| RE: PLAZA CENTRAL OFFICE PARK | | | |

**STAFF REPORT
(Preliminary Plat)**

CASE NUMBER: S/D 98-72 - PLAZA CENTRAL OFFICE PARK ADDITION

STAFF REPORT
(Final Plat, Preliminary Plat Approved 7/9/98)

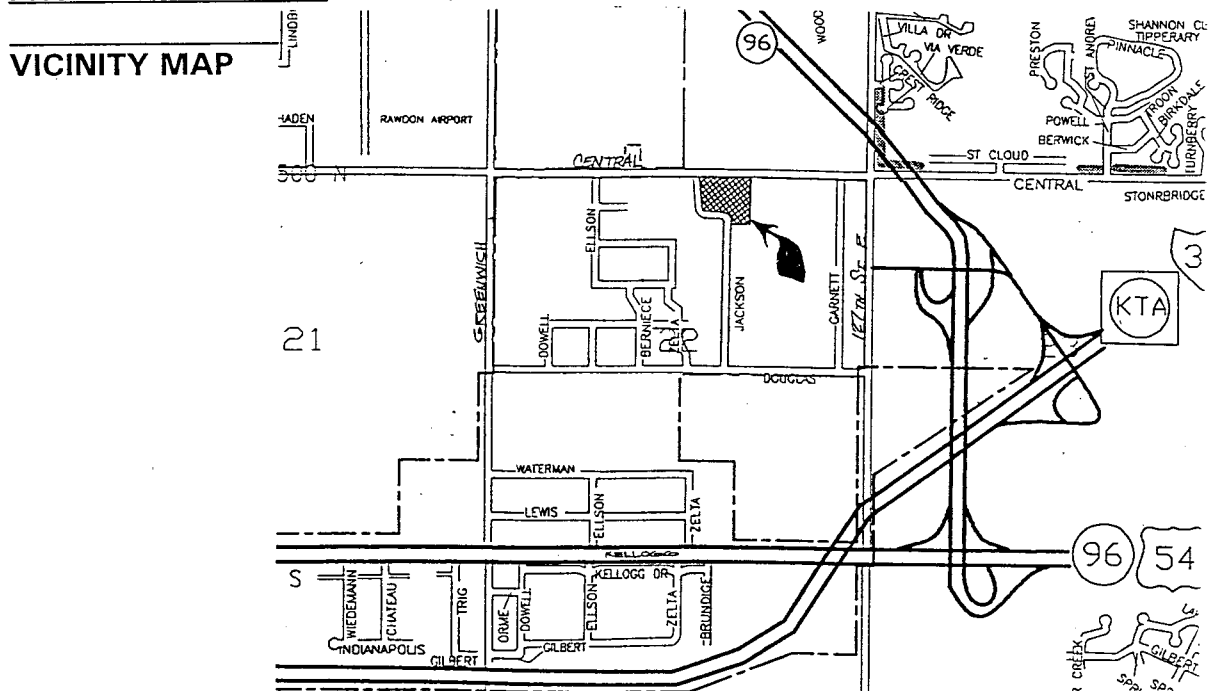
- C. City Engineering needs to comment on the status of the applicant's drainage concept.
- D. Traffic Engineering needs to comment on the proposed access controls. The Subdivision regulations encourage shared access for multiple lot subdivisions along arterials. The plat denotes one access opening per lot along Central, and a shared access between two lots along Jackson. The Protective Overlay limited the site to one opening along Jackson. On the final plat tracing, since the site is within Wichita's City limits, the plattor's text shall note that the access controls are being dedicated to the "City of Wichita" and that the location of the openings are subject to the approval of the City Engineer. ~~The applicant shall guarantee the closure of any driveway openings located in areas of complete access control or that exceed the number of allowed openings.~~

- F. Traffic Engineering needs to comment on the need for street improvements.
- G. In accordance with the Protective Overlay, a 100-ft building setback shall be

denoted from Central.

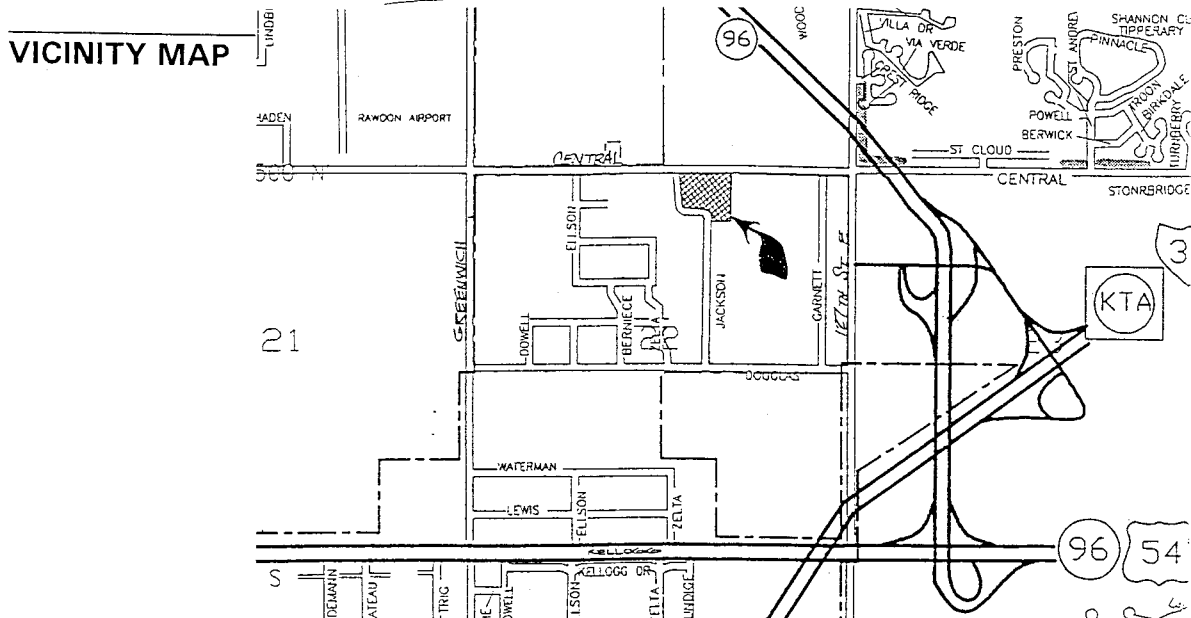
- C. **City Engineering** needs to comment on the status of the applicant's drainage plan.
- D. **Traffic Engineering** needs to comment on the proposed access controls. The Subdivision regulations encourage shared access for multiple lot subdivisions along arterials. The Protective Overlay limited the site to one opening along Jackson. **The plat shall denote a joint opening between lots 1 and 2 and one access opening on Lot 3. 150 feet of complete access control along Central shall be dedicated from the east line of the plat.**

The final plat denotes two access openings along Central (one joint access between lots 2 and 3) and a joint access between two lots along Jackson.
- E. Provision shall be made for ownership and maintenance of the reserve. For those reserves being platted for drainage purposes, the required covenant which provides for ownership and maintenance of the reserves shall grant, to the City, the authority to maintain the drainage reserves in the event the owner(s) fail to do so. The covenant shall provide for the cost of such maintenance to be charged back to the owner(s) by a method similar to special assessments.

- F. **Traffic Engineering** needs to comment on the need for street improvements. **The applicant shall guarantee the paving of Jackson to commercial street standards; and a 35-foot half street right-of-way will be needed. Complete access control along Jackson will be needed until the paving of Jackson is completed.**

The final plat denotes the additional right-of-way dedication. The off-site right-of-way dedication needs to be established by separate instrument.

- G. The final tracing shall indicate the centerline of Jackson with a bold line. The arrow denoting the off-site dedication needs to point to the correct line.
